Access Compliance Report

Public Rights-of-Way

Intersection ID: 10443	Main Street: JORDAN_PL	Cross Street: N_BREVARD_ST	Location: W
ADA ID: 2900F0640C8B	Ramp Type: Combination1	Initial Pass/Fail: Fail	Overall Compliance: No
		Severity Score: 10

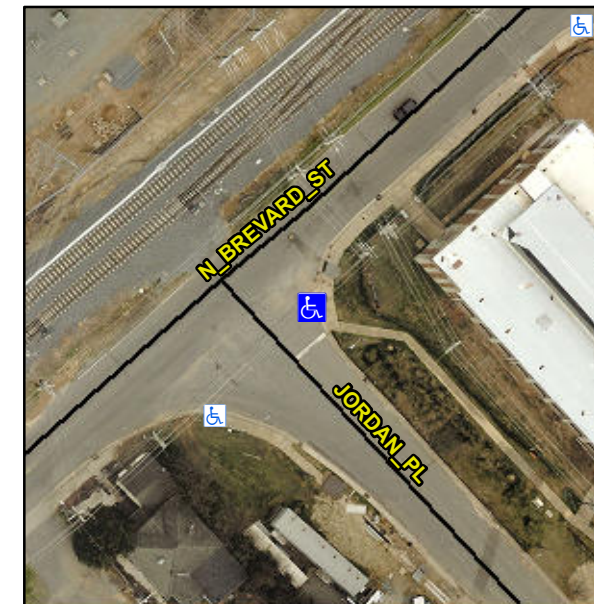
LT RP < 5%

Not Found, R304.5.1, R304.5.3

Remove & Replace Entire Ramp.
